BRADLEY HEIGHTS

AZURE GREEN
CONSULTANTS
+ feasibility + planning + engineering + surveying

PROPOSED STRUCTURES DATA

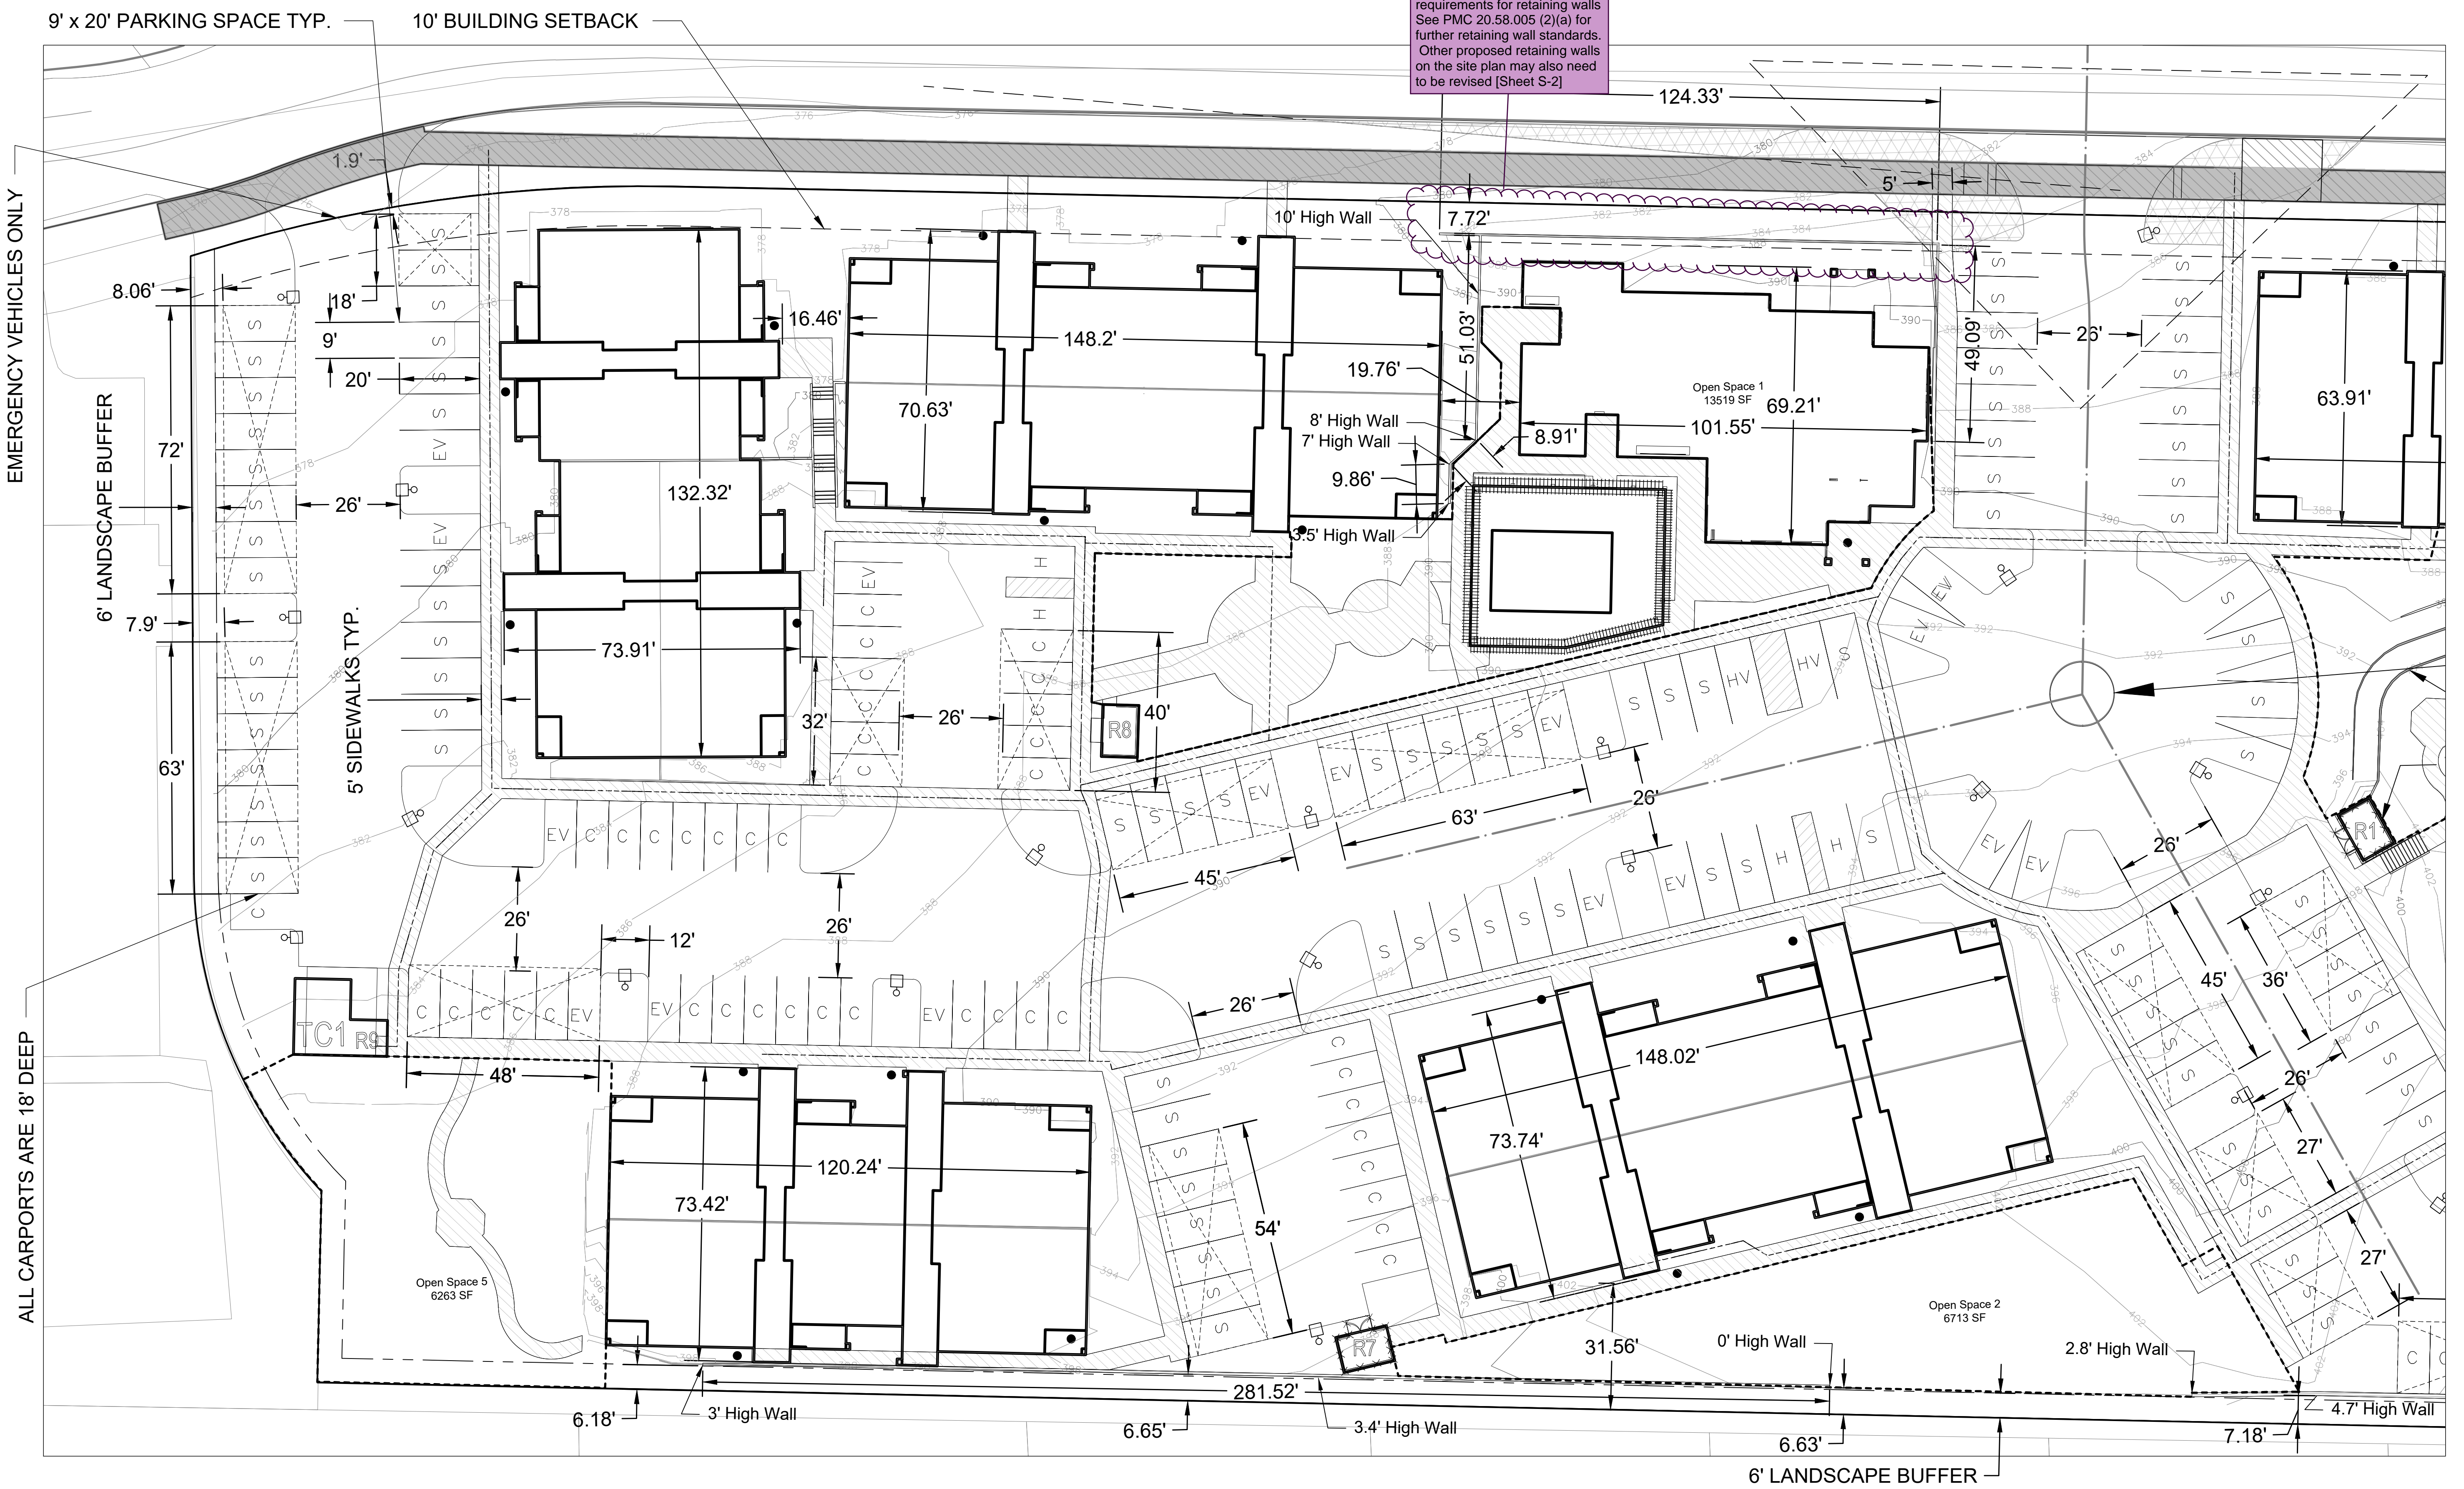
Retaining wall at recreation center does not meet 8 ft setback requirement, 3.5 ft height limit, or stepback requirements for retaining walls. See PMC 20.58.005 (2)(a) for further retaining wall standards. Other proposed retaining walls on the site plan may also need to be revised [Sheet S-2]
